## Access Compliance Report Public Rights-of-Way (Curb Ramps)

Intersection ID: 8578Main Street: DARE\_DRCross Street: HYDE\_DRLocation:SWADA ID: BEB4671E9127Ramp Type: PerpInitial Pass/Fail: FailOverall Compliance: NoSeverity Score:22.5

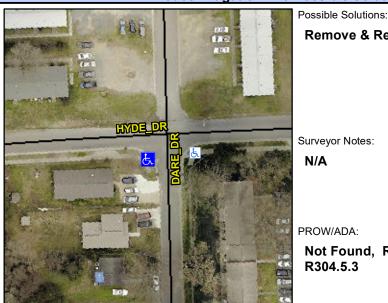
Remove & Replace Entire Ramp.
1
Surveyor Notes:
N/A
PROW/ADA:
Not Found, R304.5.1, R304.2.2,
R304.5.3
•

Compliance Description Data Compliance Description Data					Data
N/A	Ramp Length (in)	58.5	No	Ramp Slope (%)	9.7
No	Ramp Width (in)	47.0	No	Ramp XSlope (%)	2.3
N/A	Flare Type LT	N/A	N/A	Flare Type RT	N/A
N/A	Flare Slope LT (%)	N/A	N/A	Flare Slope RT (%)	N/A
N/A	Flare Traversable LT?	N/A	N/A	Flare Traversable RT?	N/A
N/A	Landing Length (in)	N/A	N/A	DWS Provided?	N/A
N/A	Landing Width (in)	N/A	N/A	DWS Contrast?	N/A
N/A	Landing Slope (%)	N/A	N/A	DWS Length (in)	N/A
N/A	Landing X Slope (%)	N/A	N/A	DWS Full Width?	N/A
N/A	Landing Curb? (Y/N)	N/A	N/A	DWS Offset (in)	N/A
N/A	Shared Landing?	N/A			
N/A	Gutter Ponding?	N/A	N/A	Gutter Slope (%)	N/A
N/A	Gutter Lip Ht (in)	N/A	N/A	Gutter X Slope (%)	N/A
N/A	Painted X Walk1?	No	N/A	Painted X Walk2?	N/A
	X Walk 1 Direction	To E		X Walk 2 Direction	N/A
N/A	X Walk 1 Width (in)	N/A	N/A	X Walk 2 Width (in)	N/A
	X Walk 1 Slope (%)	0.6		X Walk 2 Slope (%)	N/A
	X Walk 1 X Slope (%)	1.0		X Walk 2 X Slope (%)	N/A
